## TOLEDO - LUCAS COUNTY PLAN COMMISSIONS

REF: SUP25-0002

SUBJECT: Request for a Special Use Permit for a Hospital at 3325, 3329, and 3350 Collingwood Boulevard.

# SITE PLAN

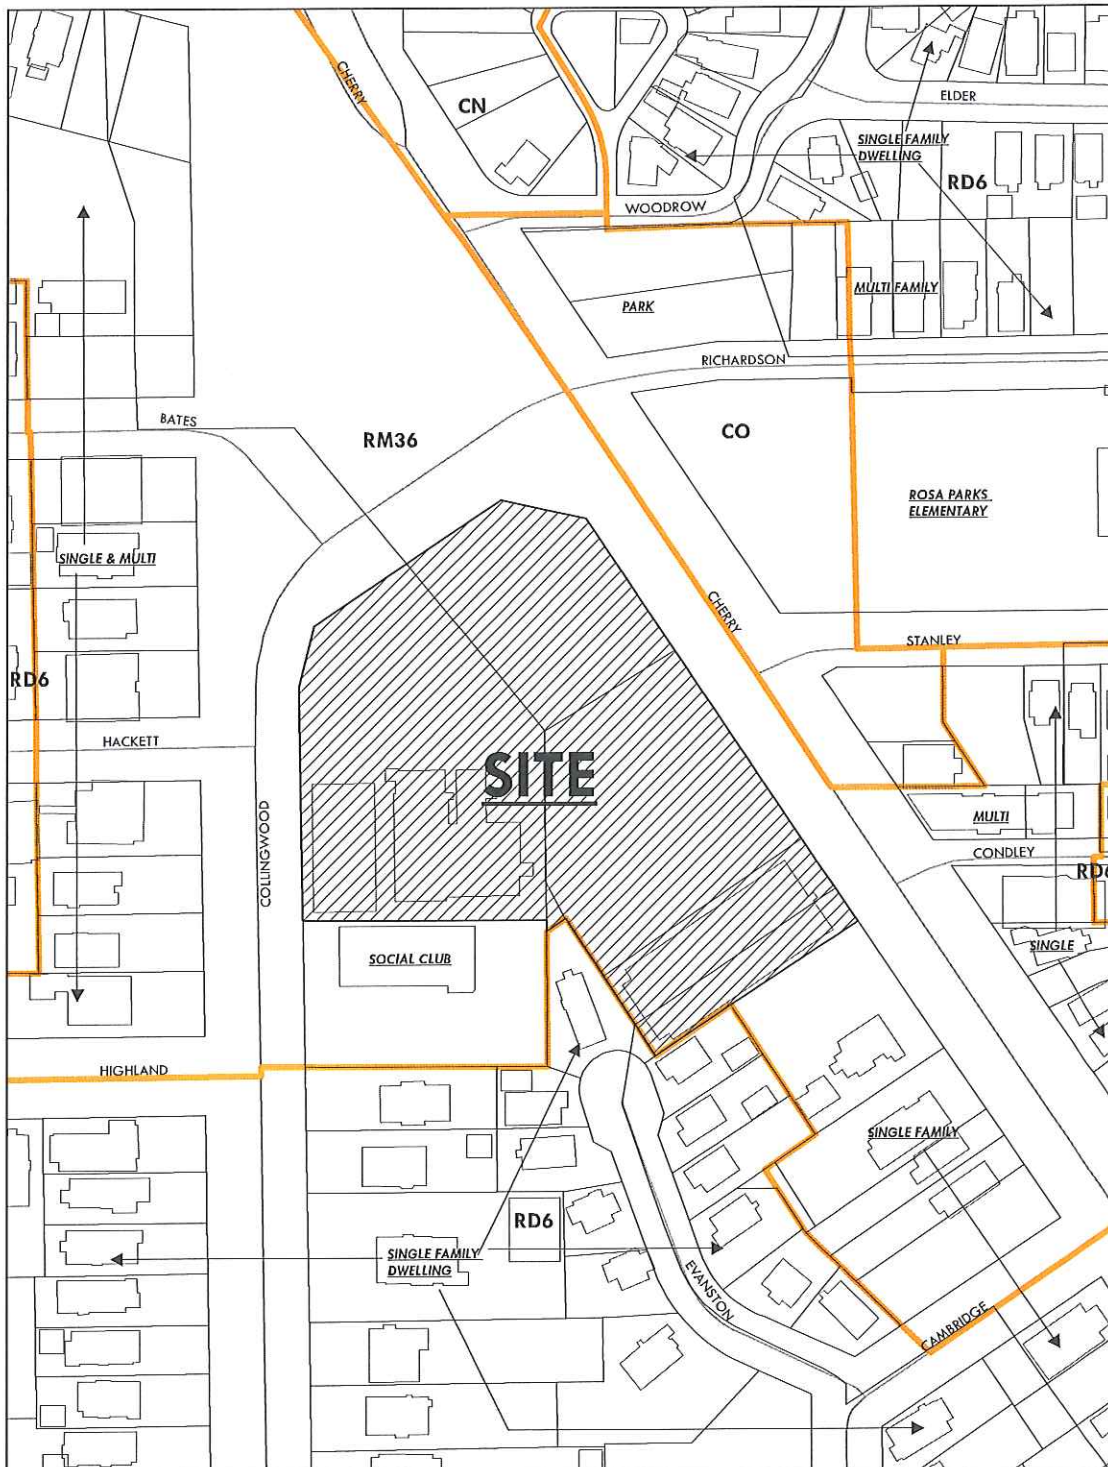
8. One (1) off-street loading zone space shall be provided with a minimum dimension of 12 by 35 feet per TMC§1107.1000. **Shall be depicted on a revised site plan.**

9. A minimum of five (5) accessible parking spaces for physically disabled persons is required. **Acceptable as depicted**
10. Parking spaces for physically disabled persons shall be in conformance with the standards of TMC§1107.1700. **Site plan depicts required signage at six feet five inches (6' 5"), signage shall not be more than six feet (6') in height above pavement level.**
